**DATE:** December 1, 2023  
**PAGE:** 1 of 4 (INCLUDING THIS PAGE)  
**TO:** ALL CONTRACTORS  
**FROM:** DENISE KING  
**PROJECT:** NEW PRODUCTION WELL ARPA  
FOR THE CITY OF LOXLEY  
GMC PROJECT NO. CMOB220078(1)  
**RE:** ADDENDUM #1

# ADDENDUM NUMBER 1

NEW PRODUCTION WELL ARPA-0018

GMC PROJECT NO. CMOB220078(1)

**CRUSHED STONE ACCESS ROAD DETAIL**

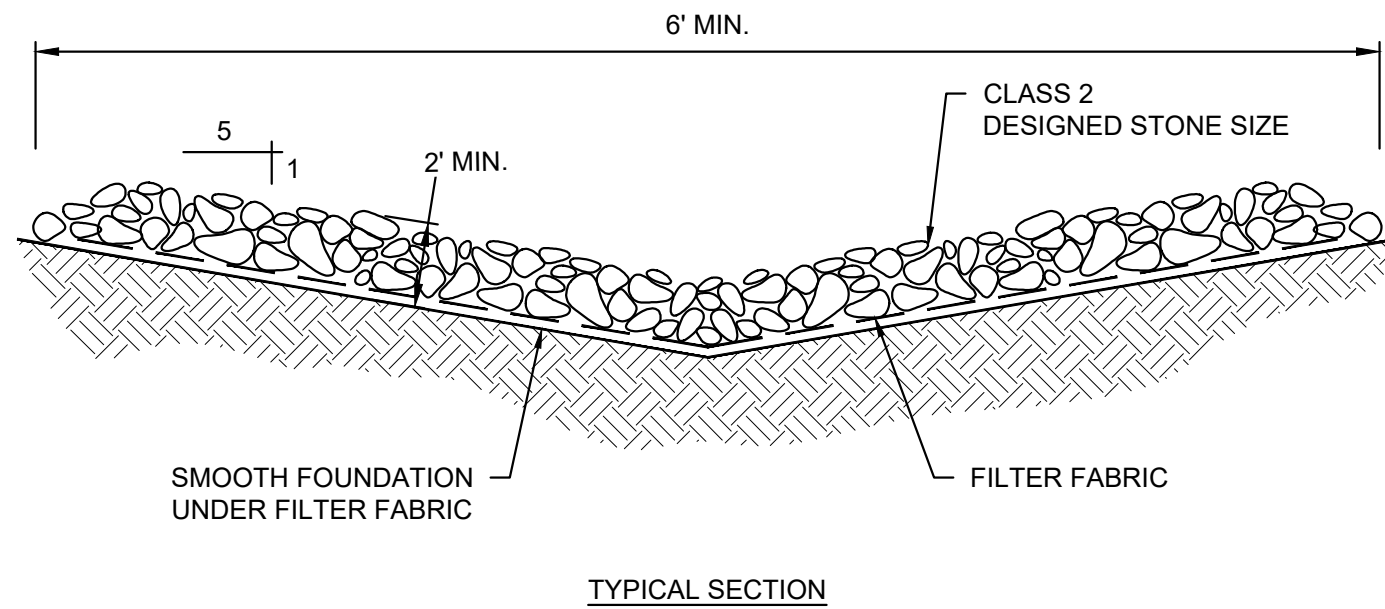
- 4.1 *Q: I’m assuming the intent for the proposed gravel access road is to construct per detail 10 on sheet C-905. There is a geotech report included in the specs for the upcoming WTP and it references “We recommend that the construction budget include removal and replacement of the upper 3 feet of the existing soils in roadways. The areas should cover 2 feet beyond the edge of pavement or back of curb.” Please confirm if the access road is to be constructed per the detail, or if we need to proceed per the recommendation in the geotech and then follow up constructing the gravel road per the detail?*

A: The access road shall be constructed in accordance with Detail 10 on Plan Sheet C-905. A revised Sheet C-905 is included with this Addendum. After compaction of the existing subgrade, the Contractor shall proofroll the subgrade in accordance with the geotechnical report. If problem soils are encountered during proofrolling, they shall be undercut and replaced to the satisfaction of the geotechnical engineer's representative.

- NOTES:**
1. CRUSHED AGGREGATE SHALL BE COMPACTED TO 98% STANDARD PROCTOR DENSITY.
  2. ACCESS ROAD SHALL INCLUDE FINISH GRADING & DITCHING AS REQUIRED TO PROVIDE POSITIVE DRAINAGE AWAY FROM CENTERLINE OF ACCESS ROAD.
  3. GEOTEXTILE FABRIC SHALL BE PROPEX GEOTEX 4X4HF, OR APPROVED EQUIVALENT.
  4. AFTER COMPACTION OF THE EXISTING SUBGRADE, PROOFROLL IN ACCORDANCE WITH THE GEOTECHNICAL REPORT. UNDERCUT & REPLACE PROBLEM SOILS AS RECOMMENDED BY THE GEOTECHNICAL ENGINEER'S REPRESENTATIVE.
